Contract #: 04-0120F4Cty: SF/ALA Rte: 80 PM: 13.2/13.9File #: 69.25B**QUALITY ASSURANCE -- NON-CONFORMANCE REPORT****Location:** Changxing Island, Shanghai, PRC**Report No:** NCR-000080**Prime Contractor:** American Bridge/Fluor Enterprises, a JV**Date:** 25-Feb-2008**Submitting Contractor:** Zhenhua Port Machinery Company, Ltd (ZPMC), Changxing Island**NCR #:** ZPMC-0078**Type of problem:****Welding****Concrete****Other****Welding****Curing****Procedural****Bridge No:** 34-0006**Joint fit-up****Coating****Other****Component:** DP57, DP59, DP 13-001, DP18-001, DP63-001, DP18-001**Procedural****Procedural****Descriptor:** OBG Deck Panel**Description of Non-Conformance:**

Job Name: SAS Superstructure

Subject: NCR No. ZPMC-0078

PROJECT: San Francisco Oakland Bay SAS Bridge Superstructure
Caltrans Contract No. 04-0120F4
ABF Job No. 660110

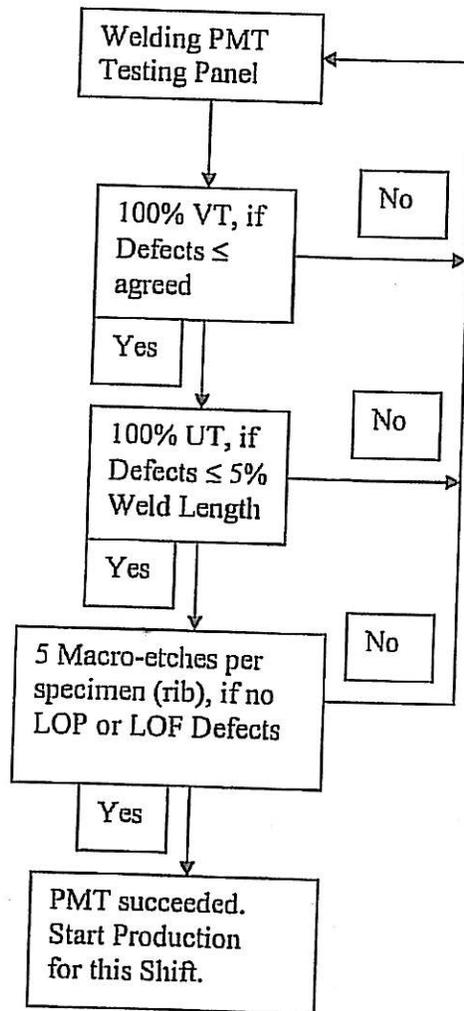
Macroetch Testing:

For each PMT specimen, 5 macro samples are to be taken at the following locations:

- 1 macro sample at 25 mm from each end. These macros are to be placed on the same side of the rib.
- 1 macro sample at a tack weld. This sample is to be placed on the same side of the rib as the end samples above.
- 2 macro samples to be determined by the engineer. These samples are to be placed on the opposite side of the rib specimen from the samples above.

Macro samples are to be taken and evaluated using AWS D1.5 for lack of penetration, and lack of fusion. Macros samples shall not be used to evaluate visual criteria. Depth of penetration less than 70% of the rib thickness is not acceptable. "Horseshoe" root discontinuity that extends into the required 80% depth of penetration is not acceptable. Any cracks detected during the macro test shall be cause for rejection of the PMT.
